INDESIT company

Model type:
MBM1822VFR

Commercial code:
F036358

Notices

N1030093fig1

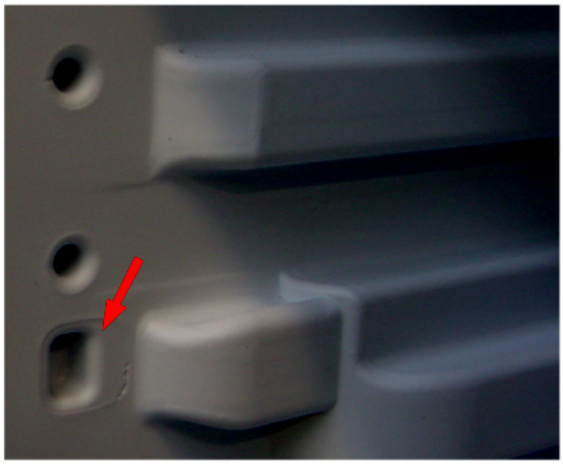
n1030093: New fixing of evaporator on static fridge-freezers (05 range) 60 cm,Melano

From August 05 (serial no. 50802.0001) the freezer evaporator is secured to the cabinet by a plastic profile.
The cabinet walls have been modified to create locations to house the profile, which is installed on the front of each evaporator plate (see photo N1030093fig1- fig2 - fig3)
The profile cannot be fitted on premodification appliances, so technical personnel must continue to fit the rh and lh supports on these models (see photo N1030093fig4)

New parts
C00141135 = WHITE PROFILE L=443.5 MM

Parts replaced
C00075596 = EVAPORATOR RH SUPPORT
C00075597 = EVAPORATOR LH SUPPORT

N1030093fig1

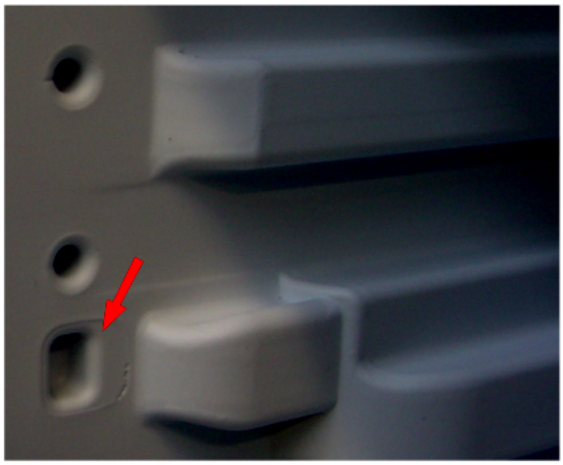
n1030094: New fixing of evaporator on static fridge-freezers (05 range) 60 cm, Lodowek

From August 05 (serial no. 50820.0001) the freezer evaporator is secured to the cabinet by a plastic profile.
The cabinet walls have been modified to create locations to house the profile, which is installed on the front of each evaporator

plate (see photo N1030093fig1- fig2 - fig3)
The profile cannot be fitted on premodification appliances, so technical personnel must continue to fit the rh and lh supports on these models (see photo N1030093fig4)

New parts
C00141135 = WHITE PROFILE L=443.5 MM

Parts replaced
C00075596 = EVAPORATOR RH SUPPORT
C00075597 = EVAPORATOR LH SUPPORT
